Professional Helicopter Pilots Association

Subj: Consolidated Los Angeles Helicopter Route Chart Change Recommendations

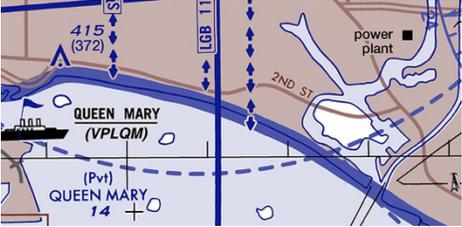
13	Bob Hope Airport helicopter frequency – remove 132.325.	Not in use but should be verified first.
14	Communication Box just south of LA/LB Harbor “In harbor area...” – recommend removing this comm box.	This box provides conflicting information with the intensive flight training box just above it. Pilots should be monitoring 122.85 in these locations. <div style="border: 1px solid black; padding: 5px; margin: 10px auto; width: fit-content;"> <p style="text-align: center; font-size: small;">IN HARBOR AREA EAST OF PALOS VERDES POINT, ALONG COASTLINE & TO/FROM CATALINA, PILOTS ARE REQUESTED TO MONITOR 121.95 FROM 4500’ AGL TO 1000’ AGL & 119.8 BELOW 1000’ AGL</p> </div>
15	Long Beach Airport Transition Routes – add text descriptions of the transition routes.	El Monte, Marina, and Santa Monica transition routes are explained at the bottom left portion of the chart, but not the Van Nuys transition
